**Petition R16-05  
Ervin Cook Road Conditional District Rezoning**

**PART 1: PROJECT SUMMARY**

1. Purpose: Rezone 224 acres north of Gilead Road and east of Ervin Cook Road from Transitional Residential to Neighborhood Residential – Conditional District (NR-CD). The proposed rezoning is to create a 382-lot

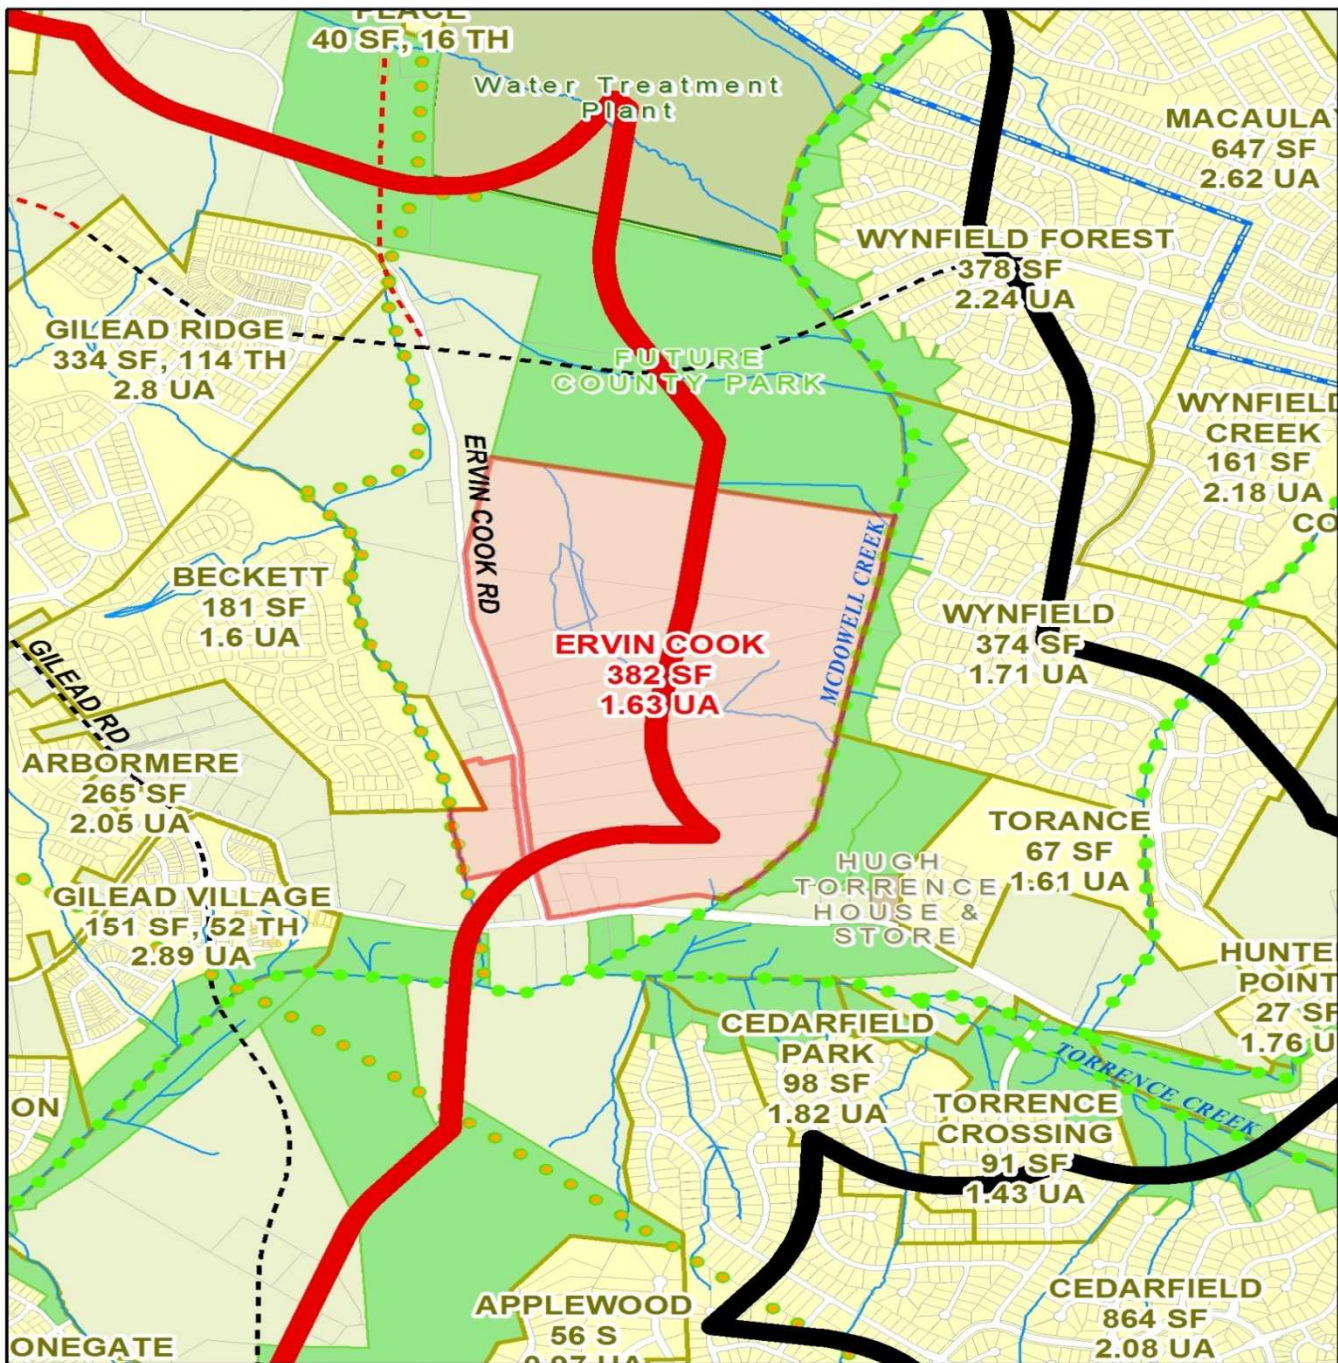
- **Policy H-1 & H-9: Development Pattern.** Continue to follow existing residential development pattern as reflected in “Map of Zoning Districts,” focusing higher intensity development generally within two miles of the I-77/NC 115 corridor.
  - Comment: The proposed CD Rezoning is split by the “High and Low Intensity Areas” line from the 2030 Community Plan (see map below). The eastern half of the project is located within the area between the High and Low Density line and the western half (along Ervin Cook Road) is located outside of the line.
- Comment: The proposed Ervin Cook Road subdivision has a density of 1.63-units per acre. The surrounding developments average 2.08, as shown on map below:

<u>East</u>	<u>West</u>	<u>North</u>	<u>South</u>
Torrance = 1.61 (NR-CD)	Beckett = 1.6 (TR)	Vacant/Farm = n/a (TR)	Vacant / SF = n/a (TR)
Wynfield = 1.71 (GR)	Gilead Ridge = 2.67 (OPS TR)		Cedarfield Park = 1.82 (GR)
Wynfield Creek = 2.18 (GR)	Gilead Village = 2.89 (OPS TR)		
Wynfield Forest = 2.24 (GR)	Arbormere = 2.05 (OPS TR)
